National Committee on Uniform Traffic Control Devices

National Committee on Uniform Traffic Control Devices (NCUTCD) Recommended Changes to Proposed Text for 11th Edition of the MUTCD Docket Number: FHWA-2020-0001

- 1 **Federal Register Item Number:** 185 to 227, 647
2 **NPA MUTCD Section Number:** 2E.01 to 2E.59, Appendix A1
3 **Legend:** Base text shown in proposal is the NPA “clean” proposed text.
4 • [NCUTCD recommendation for text to be added in final rule.](#)
5 • [NCUTCD recommendation for text to be deleted in final rule.](#)
6 • [NCUTCD recommendation for text to be moved/relocated in final rule.](#)
7 • [NPA text that was not previously approved by NCUTCD but is now approved.](#)
8 • Explanatory note: [Note that explains purpose of recommended change.]

Figure 2E-1. Destination Guide Signing for Opposing Directions of Travel

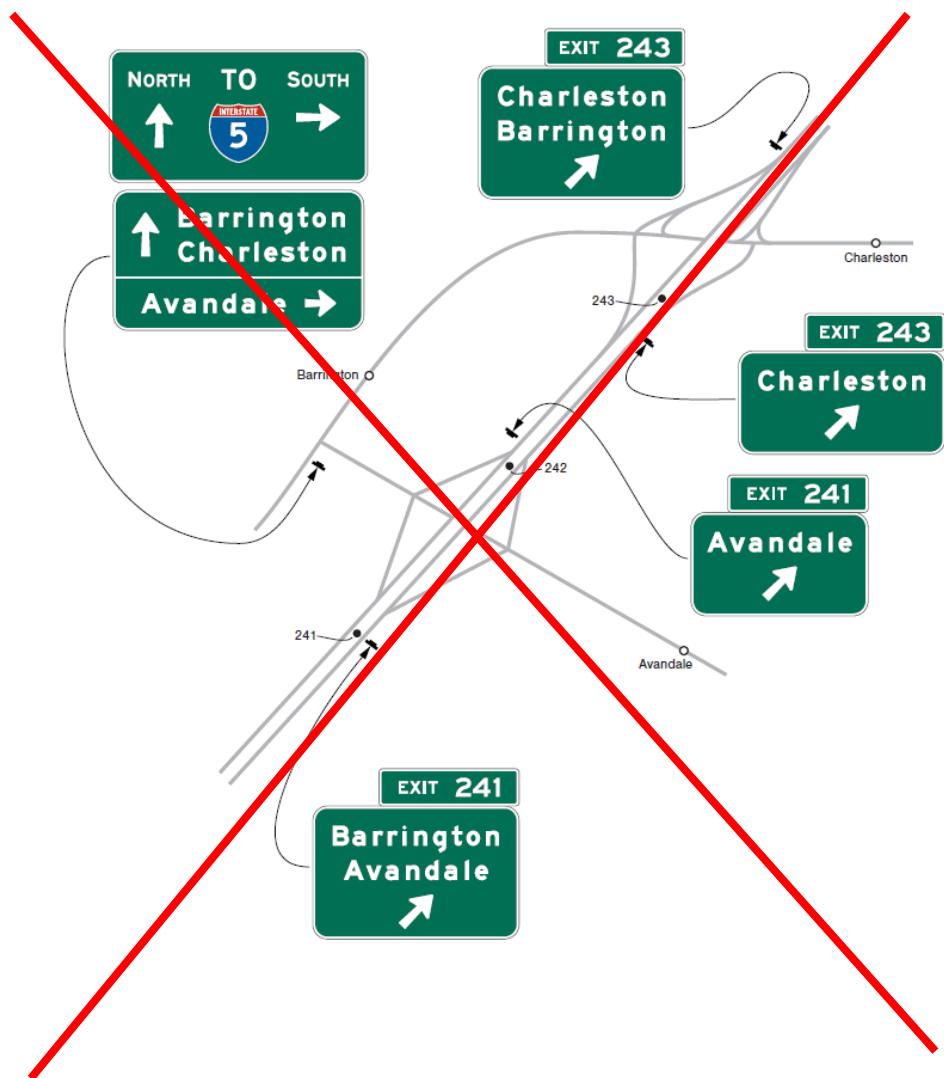
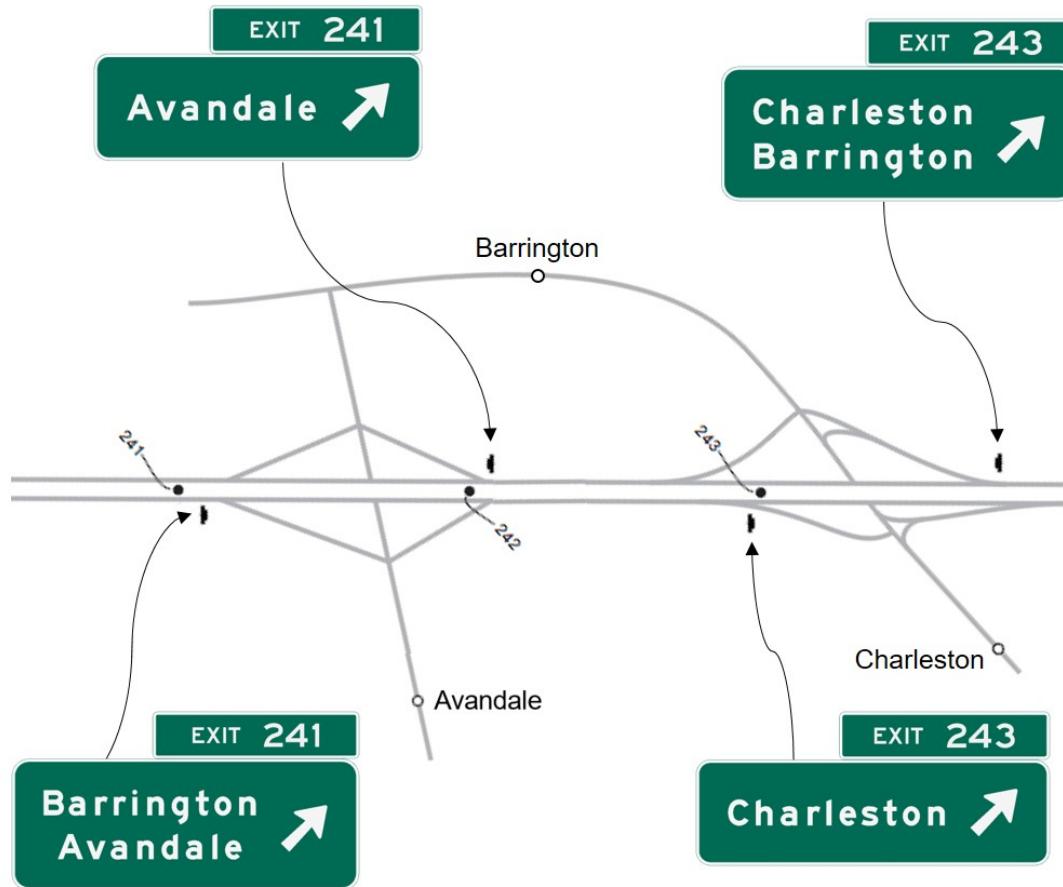
387
388
389 NCUTCD recommends revising Figure 2E-1 as follows:

- 390 • Revise the figure title from "Designation of Destinations for Interchanges in Destination
391 Guide Signing for Opposing Directions of Travel" to "Designation of Destinations for
392 Interchanges in Destination Guide Signing for Opposing Directions of Travel"
- 393 • Delete the existing figure as presented in the NPA, as the guide signs at the intersection on
394 the conventional roadway are superfluous to the purpose of this figure and add clutter and
395 distraction, the Avandale Exit 241 guide sign image is placed on the opposite side of the
396 freeway from its installed location, and the figure does not acknowledge that there is other
397 Advance Guide signing and Exit Gore signing that would be required
- 398 • Add a new Figure 2E-1 correctly depicting only the destination guide signing

Figure 2E-2. Typical Post-Interchange and Advance Interchange Guide Sign Sequences**Typical Sequence of Interchange Guide Signs**

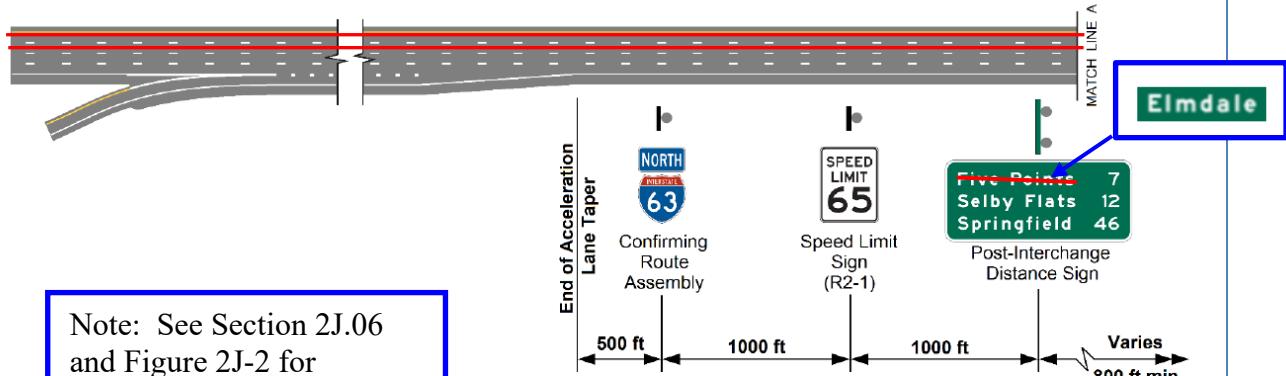
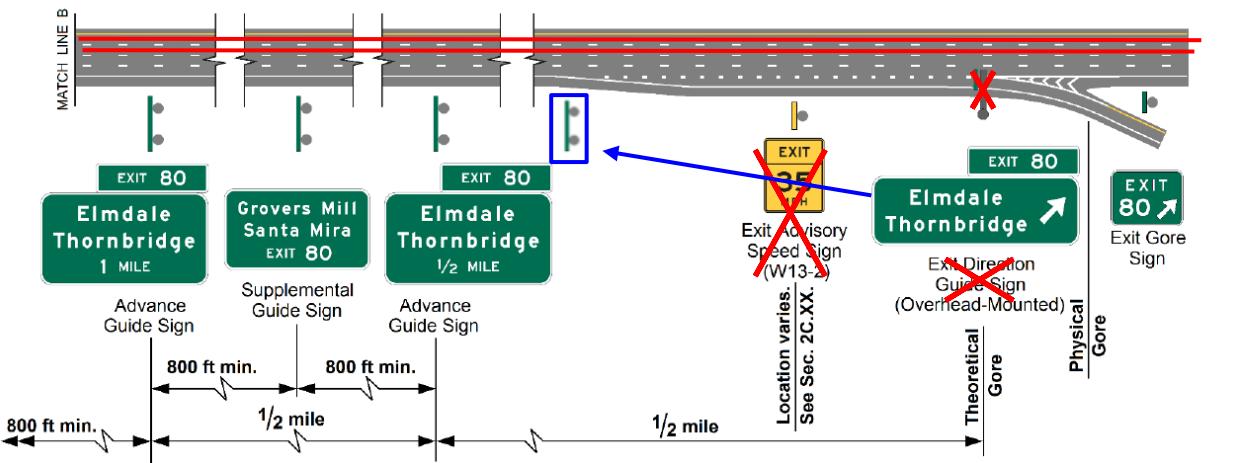
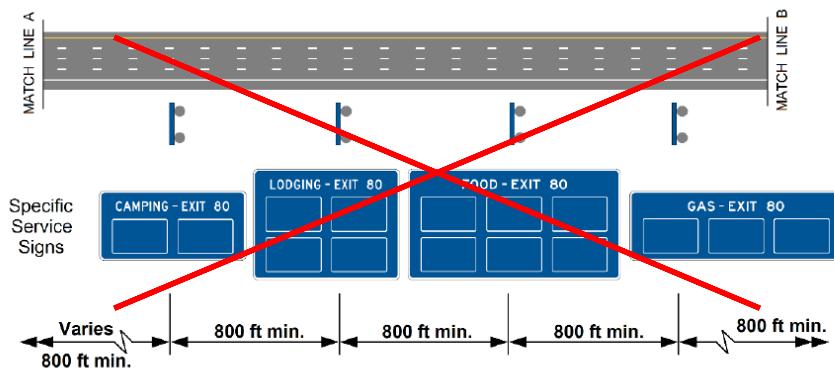
959 NCUTCD recommends revising Figure 2E-2 as follows:

- 967 • Delete the advisory speed sign as unnecessary on this figure (covered in Chapter 2C)
- 968 • Revise the first destination on the Post-Interchange Distance sign to “Elmdale 2”, as the top
969 line of the sign shall identify the next meaningful interchange per 2E.47

- 970 • Delete all the Specific Service signs and include a note stating “See Section 2J.06 and Figure
971 2J-2 for locations for Specific Service signs”, as Chapter 2J better addresses these signs

Note: See Section 2J.06
and Figure 2J-2 for
locations for Specific
Service signs

1170 **Figure 2E-6. Example of Interchange Exit Numbering for Mainline and Loop**
 1171 **Routes**

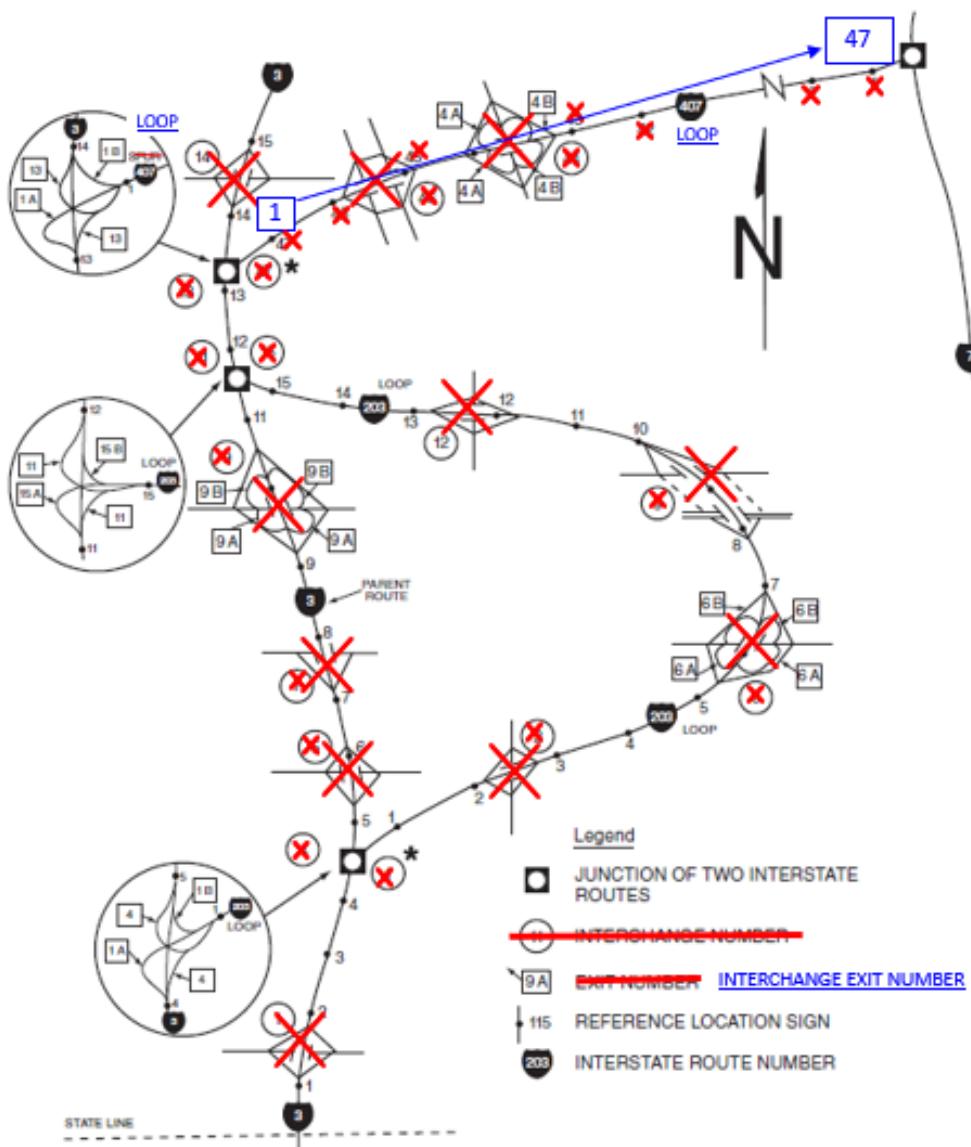
- 1160 NCUTCD recommends revising Figure 2E-6 as follows:
- 1161 • Add “Exit” in the title
- 1162 • Add “LOOP” to I-407 route shields and revise exit numbering consistent with loop routes,
- 1163 since I-407 as depicted would be a loop route
- 1164 • Delete interchanges that are not freeway-to-freeway interchanges, since they are not relevant
- 1165 to the figure, they detract from the intended purpose of the figure; and Figure 2E-3 depicts
- 1166 exit numbering for these interchanges
- 1167 • Add boxes surrounding exit numbers for consistency
- 1168 • Revise “INTERCHANGE NUMBER to INTERCHANGE EXIT NUMBER” in the note
- 1169

1184 **Figure 2E-7. Example of Interchange Exit Numbering for Mainline and Spur**
 1185 **Routes**

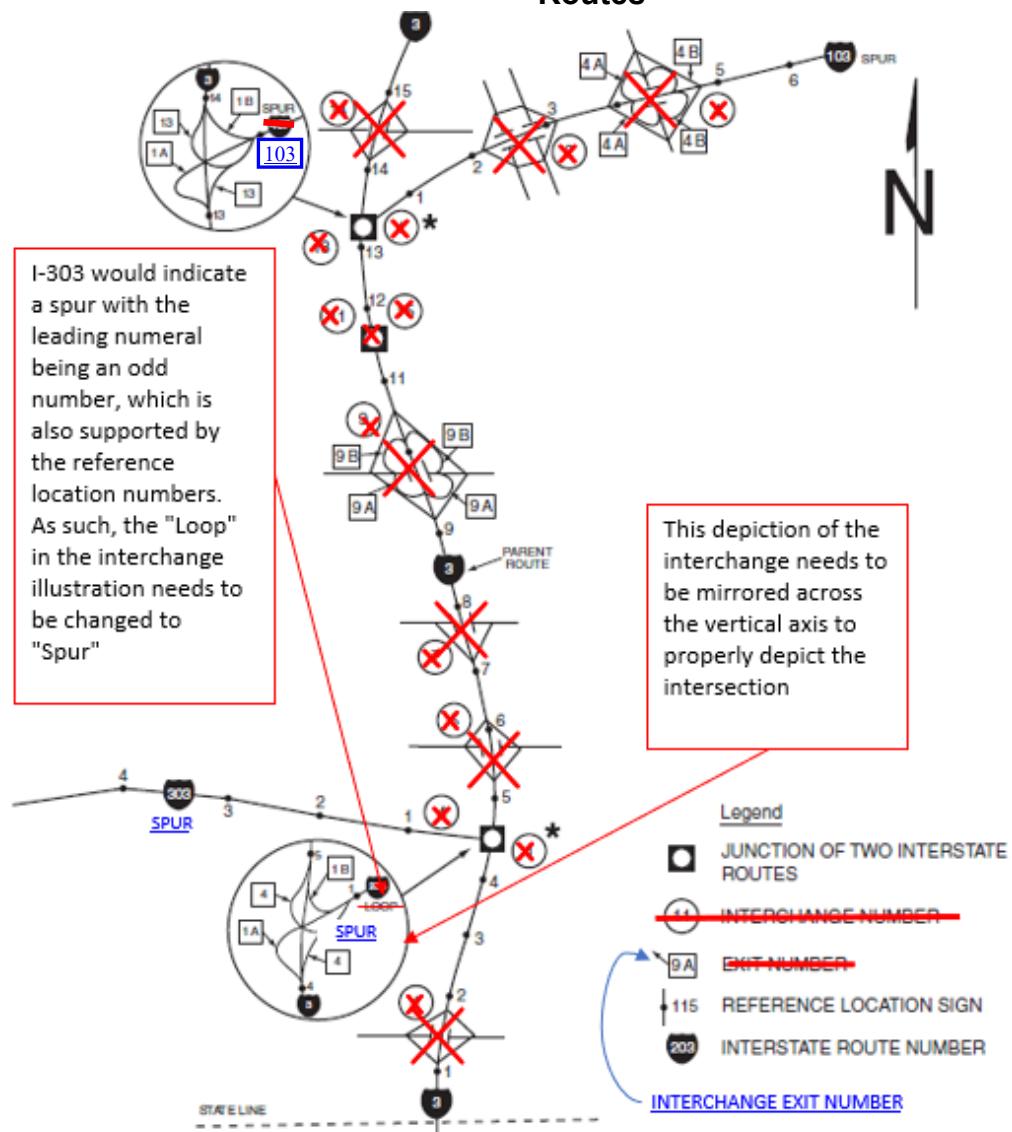
- 1173 NCUTCD recommends revising Figure 2E-7 as follows:
- 1174 • Add "Exit" in the title
- 1175 • Delete interchanges that are not freeway-to-freeway interchanges, since they are not relevant
- 1176 to the figure, they detract from the intended purpose of the figure; and Figure 2E-3 depicts
- 1177 exit numbering for these interchanges
- 1178 • Add "SPUR" to I-303 route shields since I-303 as depicted would be a spur route
- 1179 • Revise the depiction of the lowermost freeway-to-freeway interchange to match the highway
- 1180 geometrics (mirror on vertical axis)
- 1181 • Add boxes surrounding exit numbers for consistency
- 1182 • Revise "INTERCHANGE NUMBER to INTERCHANGE EXIT NUMBER" in the note
- 1183

1195
1196 **Figure 2E-8. Example of Interchange Exit Numbering for Overlapping Routes**

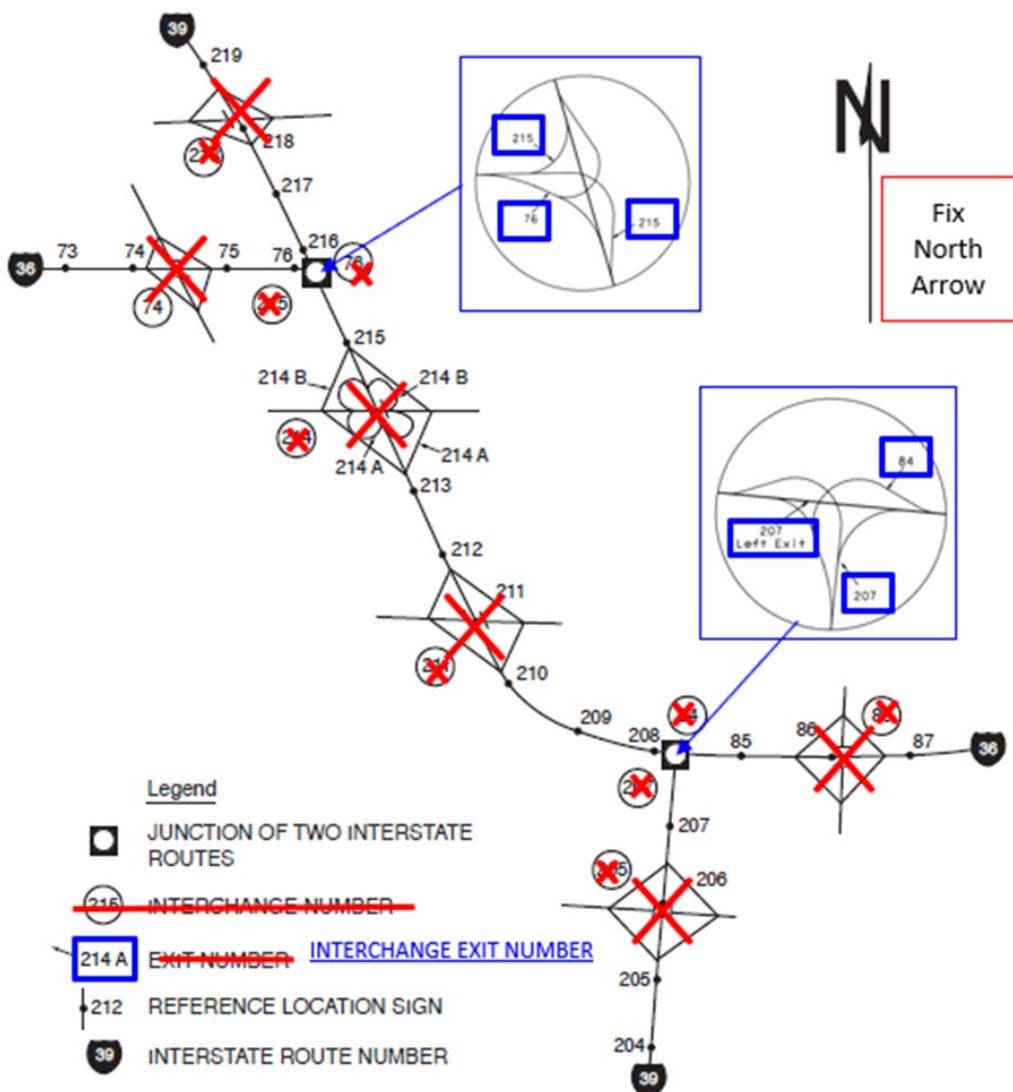
1187 NCUTCD recommends revising Figure 2E-8 as follows:

- 1188 • Add “Exit” in the title
- 1189 • Delete interchanges that are not freeway-to-freeway interchanges, since they are not relevant
- 1190 to the figure, they detract from the intended purpose of the figure; and Figure 2E-3 depicts
- 1191 exit numbering for these interchanges
- 1192 • Add boxes surrounding exit numbers for consistency
- 1193 • Fix North arrow
- 1194 • Revise “INTERCHANGE NUMBER to INTERCHANGE EXIT NUMBER” in the note

Figure 2E-14. Exit Direction Sign Placement

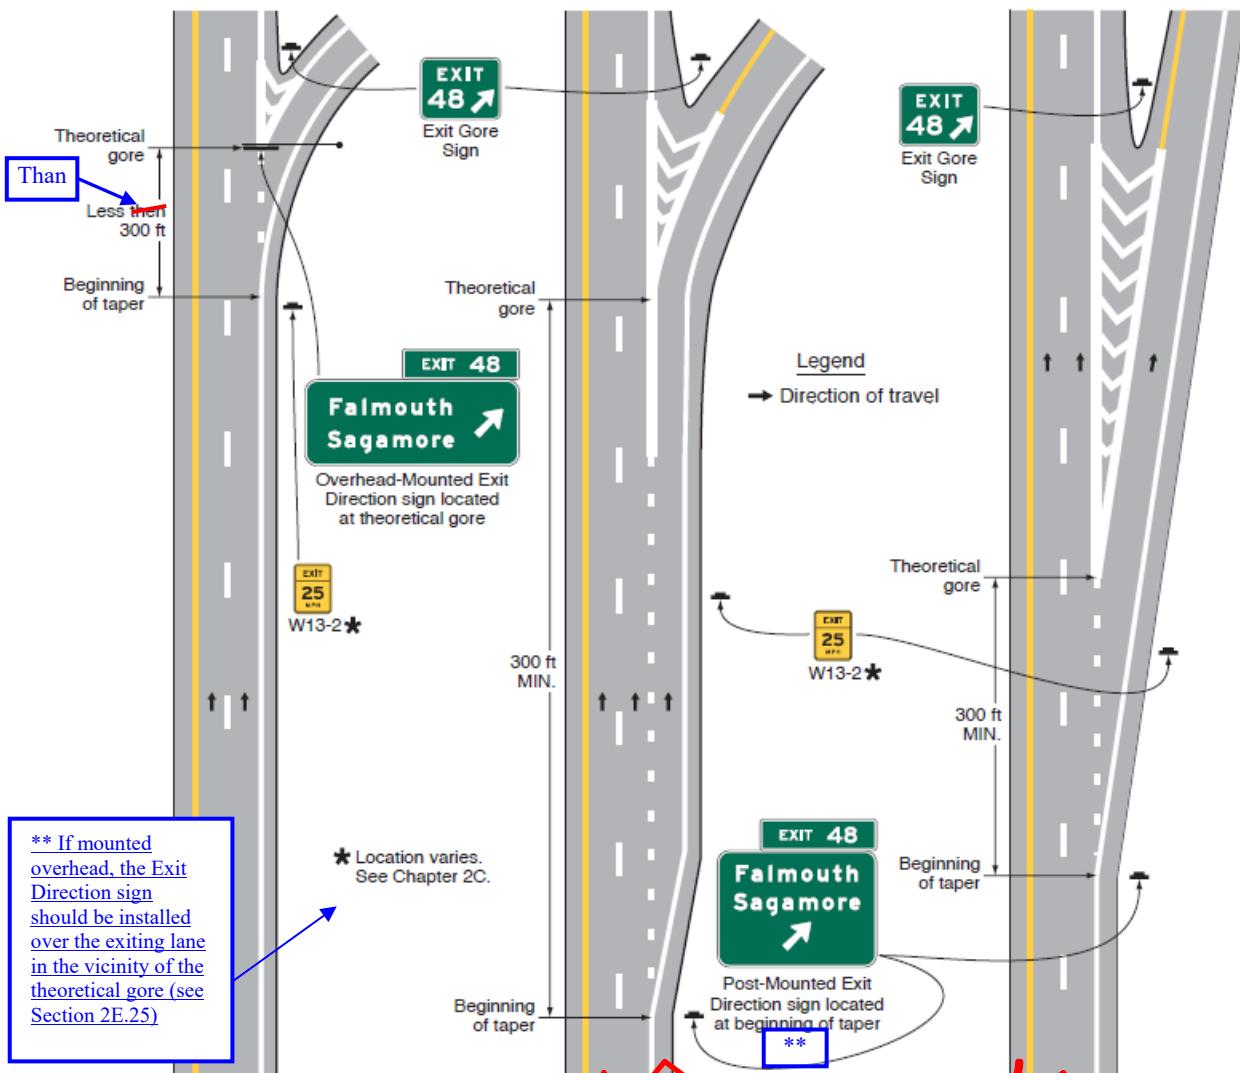
- 1462 NCUTCD recommends revising Figure 2E-14 as follows:
- 1463 • Revise the order of the three drawings so that they are in a more logical order (shortest
1464 deceleration lane to longest) by switching the center and right drawings
- 1465 • Add a double asterisk for a double asterisk footnote at the bottom of the figure that reads “If
1466 mounted overhead, the Exit Direction sign should be installed over the exiting lane in the
1467 vicinity of the theoretical gore (see Section 2E.25)”
- 1468 • Fix typo in dimension
- 1469

Figure 2E-15. Exit Gore Signs and Plaques

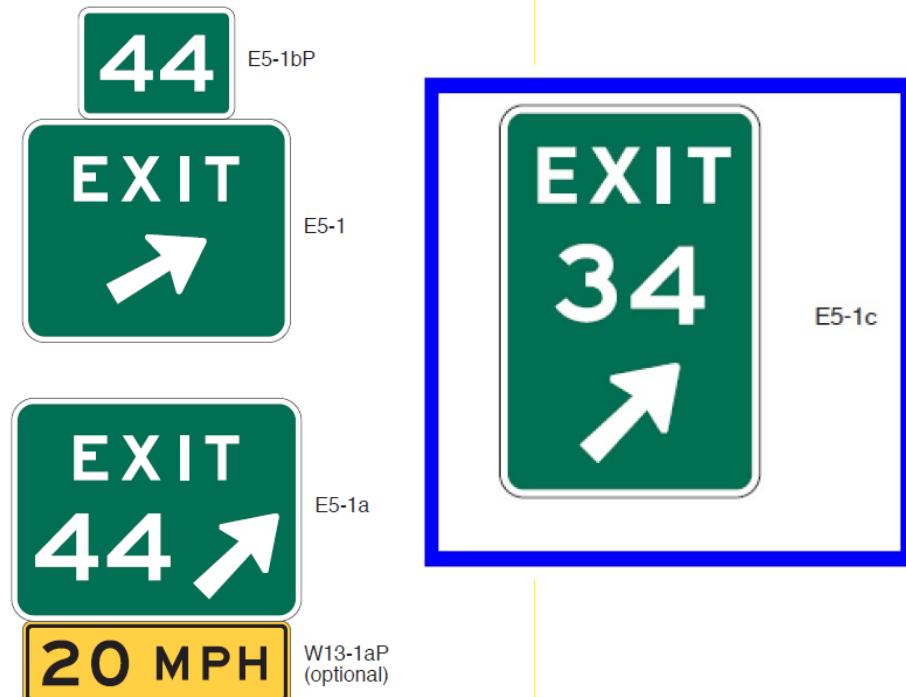
1569 NCUTCD generally agrees with Figure 2E-15 as presented in the NPA, but recommends adding
1570 the E5-1c sign to the figure.
1571

Figure 2E-21. Example of Post-Mounted Advance Guide and Supplemental Warning Signs for a Dropped Auxiliary Lane Between Separate Interchange Ramps

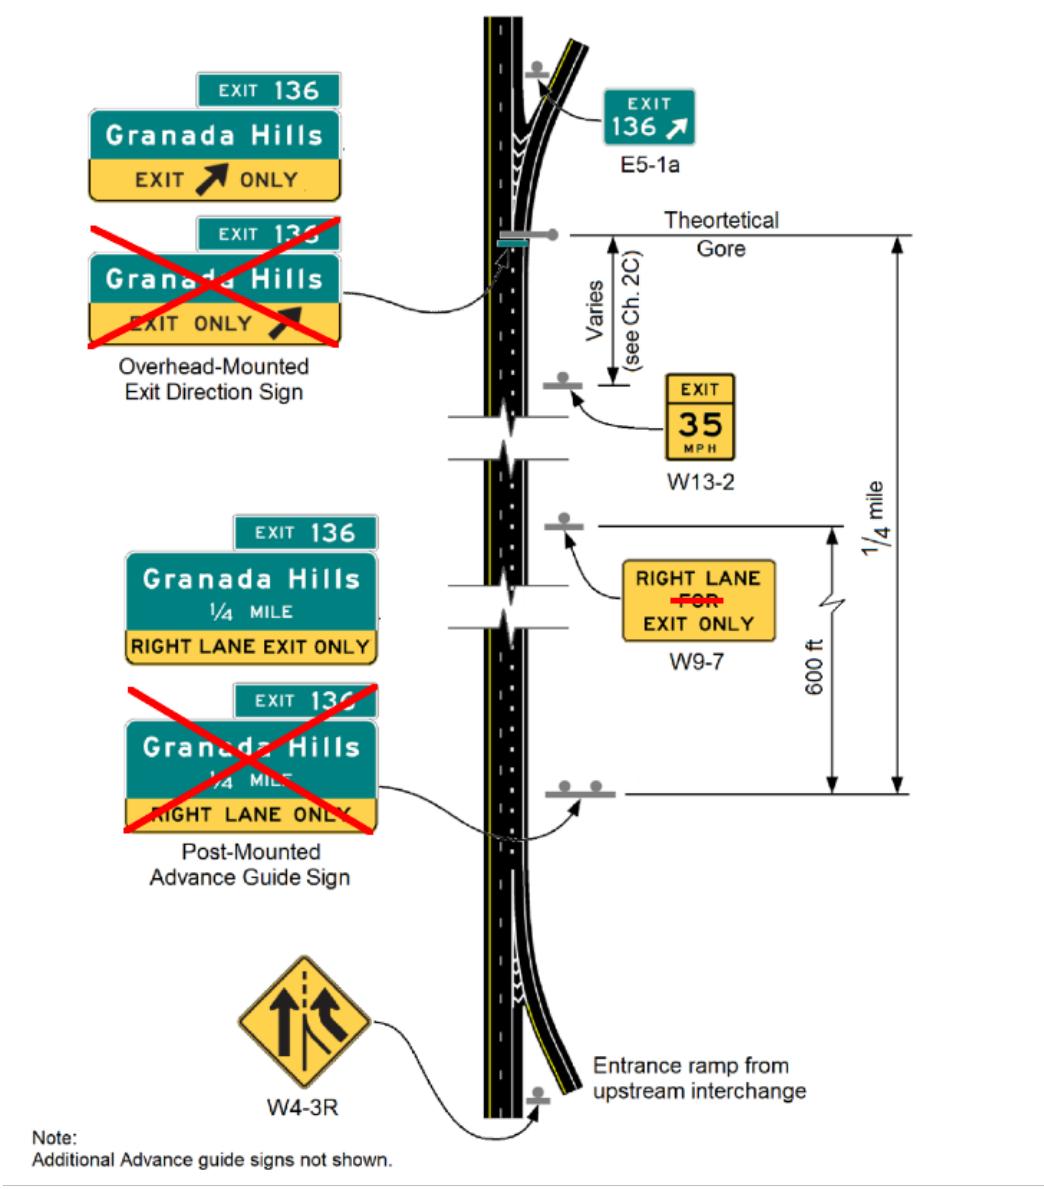
- 1721 NCUTCD recommends revising Figure 2E-21 as follows:
- 1722 • Revise the EXIT ONLY panel on the Exit Direction sign to place the arrow between the
- 1723 words EXIT and ONLY, as this is the “standard” application
- 1724 • Delete the “FOR” on the W9-7 in accordance with NCUTCD recommendations on Chapter
- 1725 2C
- 1726 • Revise the lower panel on the $\frac{1}{4}$ mile advance guide sign to read “RIGHT LANE EXIT
- 1727 ONLY” to be consistent with the revised W9-7 legend
- 1728
